2021 IRC AMENDMENTS – CHAPTER 1

R101.1 Title. These regulations shall be known as the *Residential Code for One- and Two-family Dwellings* of the City of Carrollton, and shall be cited as such and will be referred to herein as “this code.”

FIGURE R307.4 BLOCKING AT WATER CLOSET

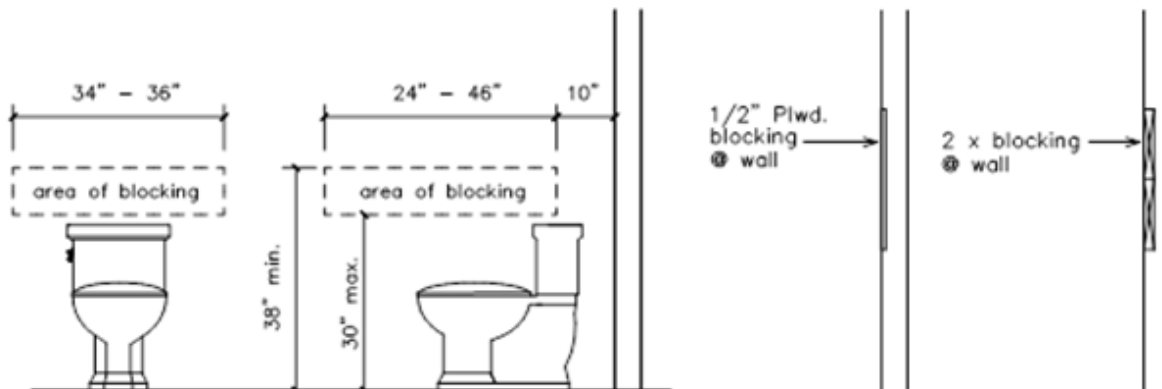
R307.3 Blocking. Required at one water closet at grade level. Blocking per Section R307.4 and Figure R307.4 shall be installed at rear wall and one wall adjacent to toilet at the lowest living level where a toilet is provided.

*****Section R307.4; add to read as follows and insert Figure R307.4:**

R307.4 Blocking. Blocking may be 1/2" plywood or equivalent or 2 x solid wood blocking flush with wall.

****Figure R602.6.1; delete the figure and insert the following figure:**

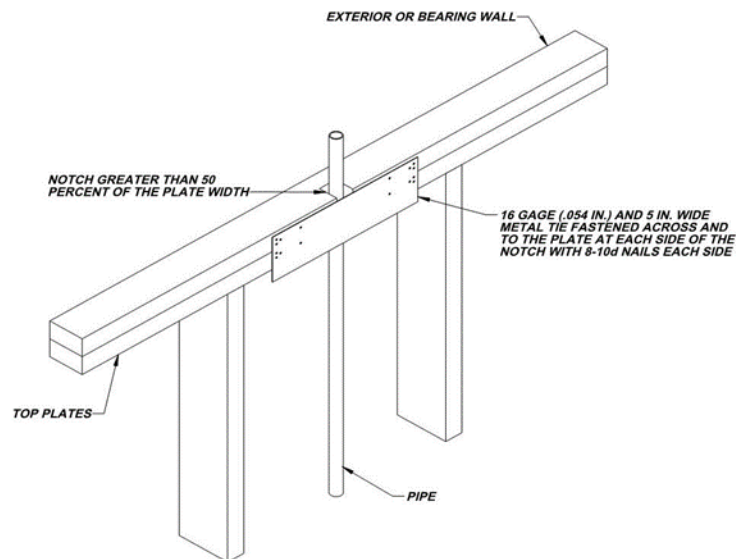
R602.6.1 Drilling and notching of top plate. When piping or ductwork is placed in or partly in an exterior wall or interior *load-bearing* wall, necessitating cutting, drilling or notching of the top plate by more than 50 percent of its width, a galvanized metal tie not less than 0.054 inch thick (1.37 mm) (16 ga) and ~~1½ inches (38 mm)~~ 5 inches (127 mm) wide shall be fastened across and to the plate at each side of the opening with not less than eight 10d (0.148 inch diameter) nails having a minimum length of 1½ inches (38 mm) at each side or equivalent. Fasteners shall be offset to prevent splitting of the top plate material. The metal tie must extend not less than 6 inches past the opening. See Figure R602.6.1. *[Remainder unchanged]*
